BEFORE THE UNITED STATES NUCLEAR REGULATORY COMMISSION

This amendment consists of Proposed Change No. 194 to Provisional  
Operating License No. DPR-13. Proposed Change No. 194 modifies the Technical  
Specifications incorporated in Provisional Operating License No. DPR-13 as  
Appendix A.

Proposed Change No. 194 is a request to revise Appendix A Technical  
Specifications to modify the positive barrier isolation requirements between  
the feedwater condensate system and the reactor coolant system due to power  
supply modifications to a recirculation valve.

DESCRIPTION AND SIGNIFICANT HAZARDS CONSIDERATION ANALYSIS  
OF PROPOSED CHANGE NO. 194 TO THE TECHNICAL SPECIFICATIONS  
PROVISIONAL OPERATING LICENSE NO. DPR-13

FIGURE 1 - EXISTING AND PROPOSED POWER SUPPLY CONFIGURATIONS FOR UPS

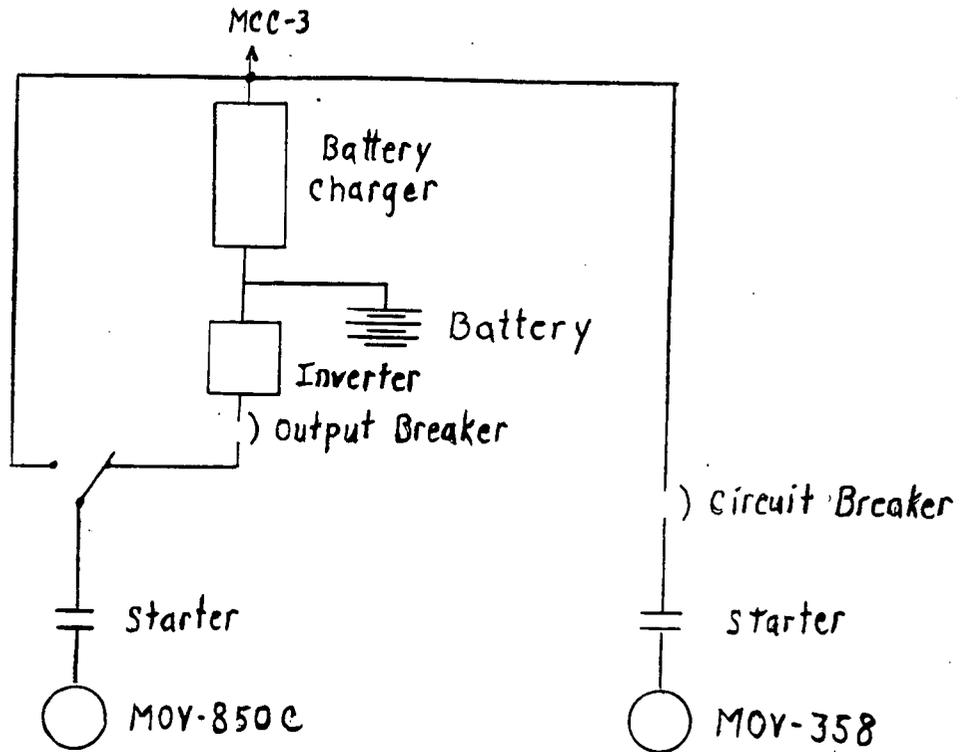
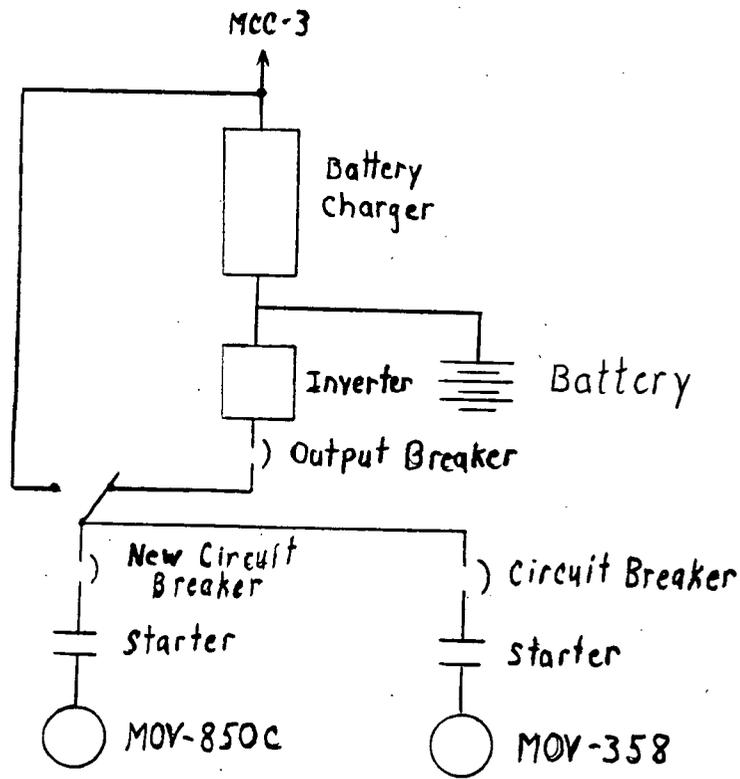
In order to eliminate a single failure susceptibility in the recirculation system, the power supply for recirculation valve MOV-358 will be changed to be included on the Uninterruptible Power Supply (UPS) for MOV-850C. The design modifications to accommodate this change in power supply require revision to Technical Specification 3.3.2 which defines the "positive barrier" requirements between the feedwater condensate system and the piping connections to the reactor coolant system. Specification 3.3.2.A(1) will be revised to eliminate the specific requirement for MOV-850C, and replace the words "safety switches" with "supply breakers." In addition the basis for Technical Specification 3.7 will be revised to reflect the new service requirement for the UPS.

1. Change the power supply for recirculation valve MOV-358 to be included on the Uninterruptible Power Supply (UPS) for safety injection isolation valve MOV-850C, and
2. Provide a new supply breaker for MOV-850C downstream of the inverter output breaker and transfer switch to support maintenance activities and testing of the valves.

In review of the technical specifications to evaluate any impact from these modifications, it was determined that the positive barrier isolation requirements between the feedwater and RCS defined by Specification 3.3.2 would require revision. MOV-850C serves as one of the two isolation barriers on a section of piping between the feedwater system and the RCS, and thus is subject to the provisions of Specification 3.3.2. In accordance with these provisions, the inverter output breaker feeding MOV-850C must be open whenever fuel assemblies are in the vessel and the RCS pressure is less than 500 psig. With the addition of MOV-358 to the same inverter, opening of the inverter output breaker would remove power to MOV-358 as well as MOV-850C. This configuration is not necessary nor desirable because MOV-358 is not subject to the positive barrier requirements of Specification 3.3.2. For this reason, individual supply breakers will be provided for both MOV-850C and MOV-358 such that control power can be removed from MOV-850C without impacting MOV-358. The existing and proposed power supply configurations for MOV-358 and MOV-850C are illustrated in Figure 1.
